From J. A. JONES, Esq., MEM. INST. C.E., F.R.S.E., Sanitary Engineer to Government, to the Chief Secretary to Government, dated Fort St. George, November 1893, No. 2431.

REMARKS of the Sanitary Engineer to Government on Mr. Cousins' Report on the Drainage and water-supply and the improvement of the River Cooum Madras.

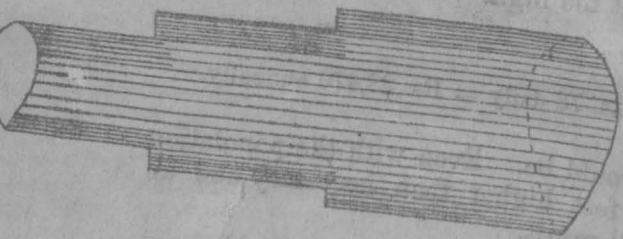
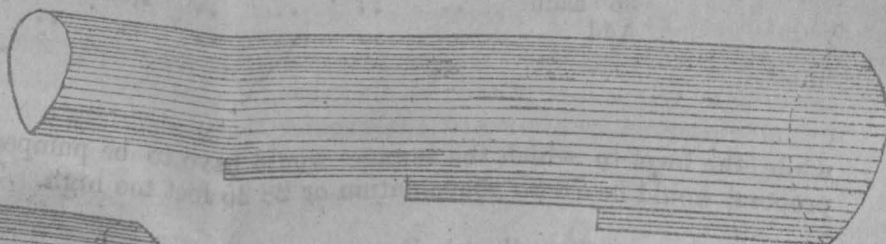
20. Two sewers carry this to the outfall; each is an ovoid sewer in size 1' 10" $\times$ 2' 9", these have a fall of $4\frac{1}{4}$ feet per mile. The one sewer carries about $\frac{1}{3}$ rd and the other $\frac{2}{3}$ rds of the total sewage of the above population, that is, the minimum flow in one will be 26, and in the other 14, cubic feet per minute.

27. Another, and I think illegitimate, manner to which the sewer depths have been reduced is due to the design at the point where one size of sewer merges into the other. Mr. Cousins' plan is thus—

but as the larger sewers will have a greater depth of flow than the smaller, the discharges of the smaller sewers are by this plan reduced. The sewers should be designed according to the extra depth of sewage to be carried thus—

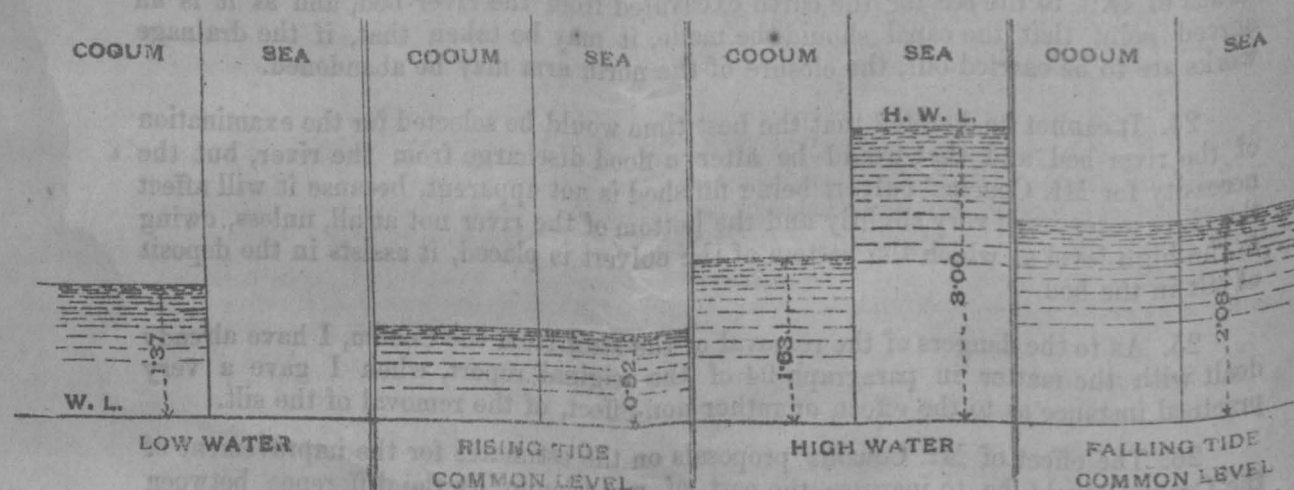
16. But with an entrance so throttled as that proposed it was evident that the condition of inflow and outflow would be very much modified than if through a comparatively wide mouth, and it was desirable that a mathematical investigation should be made; the question is by no means an easy one, but Major Love and Mr. Middlemast, of the College of Engineering, have gone carefully into the matter, and in the following are some of the results.

18. It was found that, under the above conditions, the first tide would raise the Cooum 1.09 feet and after n tides the depth in the river above low water would be—

FT.
at low tide in sea	1.37
at common level (tide rising)	0.92
at high tide in sea	1.63
at common level (tide falling)	2.08
at low tide in sea	1.37
